TAB Punch List CFA 05925 Broadview Heights FSU

Prepared by Cody Collett

Feb 16, 2026

#59 [DUCT 498] [NEW] CRITICAL (DESIGN) – AC-3 Duct undersized.

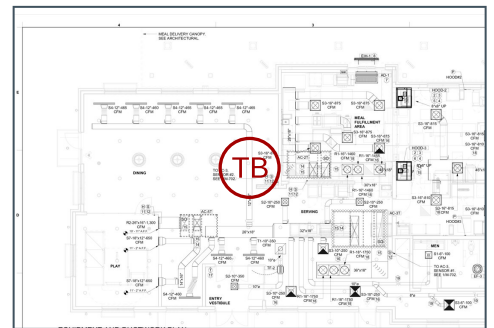
AC-3 12x14 is undersized for the design CFM and would require 1988 FPM to meet design CFM. Unit took 3 speed increases and 3 balancing passes to get the entire branch as close to design as possible.
